BOARD ACTION REPORT – APPEALABLE ITEM

Project Name: Oceanview Townhomes
Project Location: 2521 Oceanview Avenue
Request: Class V Site Plan
Board: Site Plan Review and Appearance Board (SPRAB)
Meeting Date: March 9, 2016

---STAFF REPORT---

ITEM: **Oceanview Townhomes** - Class V Site Plan, Landscape Plan and Architectural Elevations associated with construction of four one-story townhomes with each consisting of three bedrooms, two bathrooms and a rear patio.

Exterior Elevations

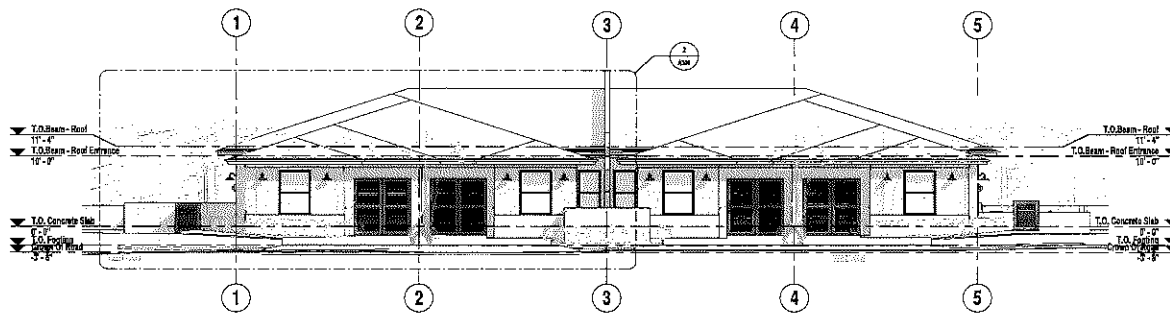
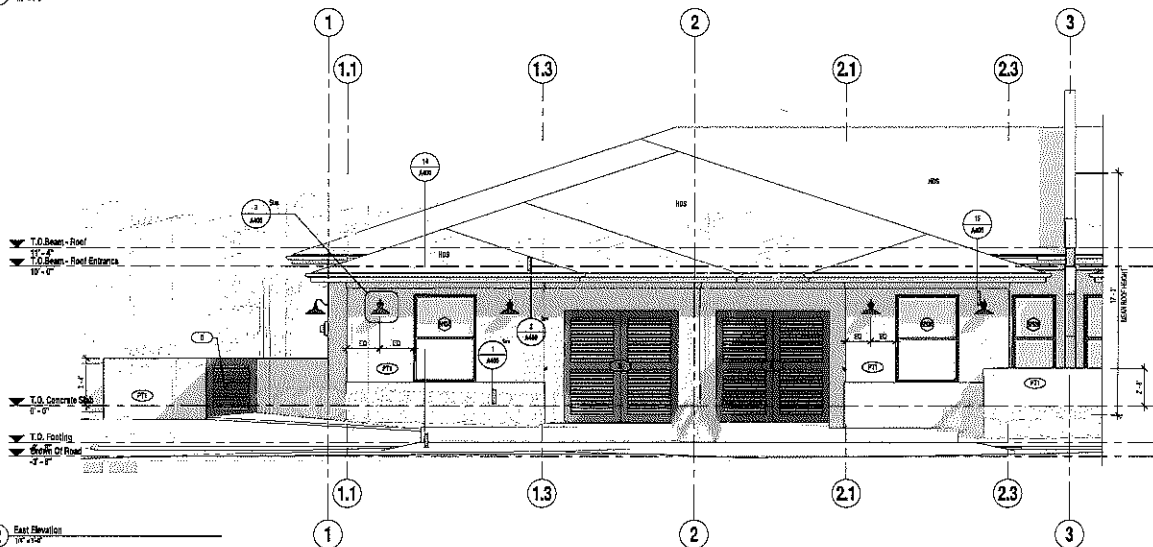
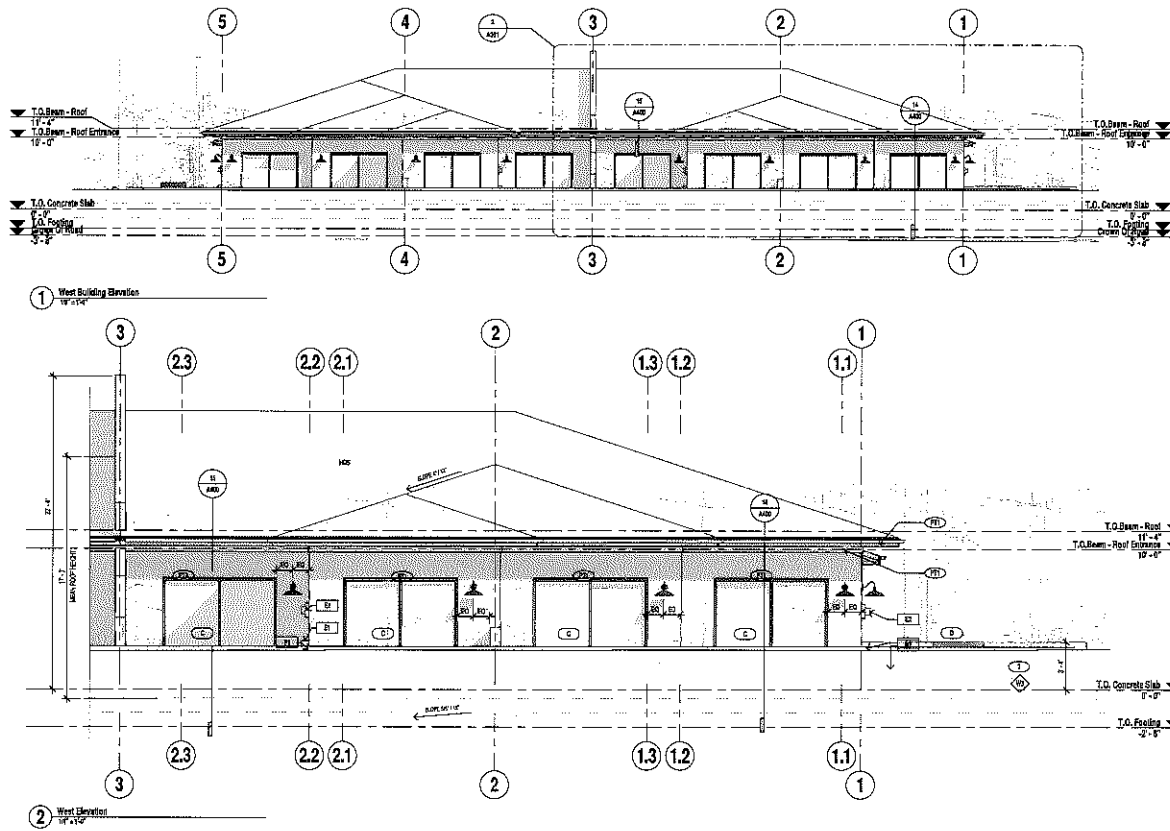
- Had concerns regarding the simplicity and monochrome design of the architectural elevations. Specifically, the wall that separates the units along the west elevation extends above the roof line, and was not a preferred architectural feature. The architect reiterated his intent for a clean, contemporary design style and deemed the wall necessary for privacy purposes as well as to meet fire code separation requirements.
